CiDesign Firmware Release Note

Release model: iR16IS4ER / iR16IS2ER/ iR16SASER/iR16FC4ER

Version: 1.0.9 (20101208_1700)

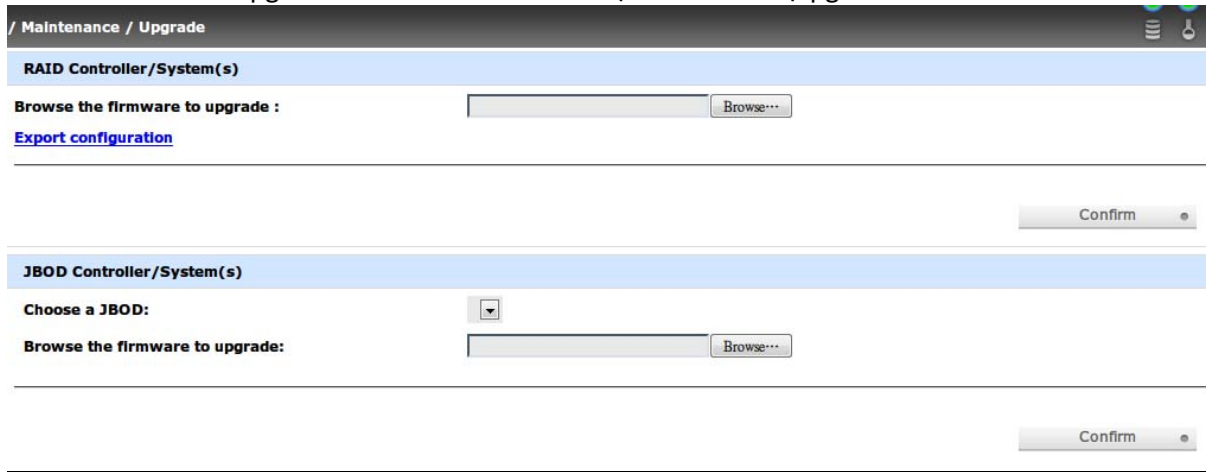
5. Break the 2TB physical disk limitation on Marvell SATA chipset model.
(iR16IS2ER)
6. Add JBOD FW upgrade function in WEB UI at \maintenance\upgrade
